APPLICANT: Tennessee Valley Authority (TVA)  
FACILITY: Watts Bar Nuclear Plant, Units 1 and 2  
SUBJECT: MEETING SUMMARY - AUGUST 30, 1994 MEETING WITH THE TENNESSEE VALLEY AUTHORITY REGARDING PROPOSED USE OF THERMO-LAG FIRE RETARDANT MATERIAL (TAC M63648)  
REFERENCE: Meeting notice by P. S. Tam, August 10, 1994

On August 30, 1994, NRC and TVA representatives met in Rockville, Maryland, to discuss TVA's proposed use of Thermo-Lag fire retardant material at Watts Bar, in particular, TVA's ampacity derating tests and associated test plan. Meeting participants and observers are listed in Enclosure 1.

**Figure A1 Schematic for calculation of conduit heat losses**

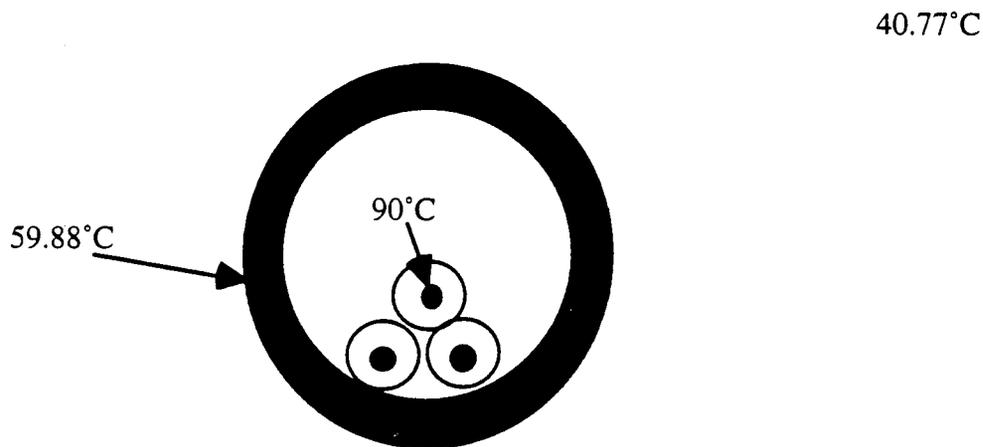
The TVA report<sup>22</sup> includes information on the temperature of the outside of the conduit for the unprotected case. For a 1" conduit, the outer conduit temperature was 59.88°C when the conductor temperature was 90°C and the ambient temperature was 40.77°C. (Figure A1).

We can calculate an effective thermal resistance (per unit length) from the conductor to the outside of the conduit by equating the heat flow from the conductor to the outside of the conduit to the heat flow from the conduit to the surrounding room.

Here we have assumed that  $\epsilon = 0.22$ , a typical value for steel.  $T_i$  is the temperature of the conductor (90°C),  $T_o$  is the temperature of the outside of the conduit (59.88°C), and  $T_\infty$  is the temperature of the surrounding enclosure (40.77°C). Here we have assumed that the surrounding air temperature used to calculate conduction is equal to the enclosure wall temperature used to calculate radiation.
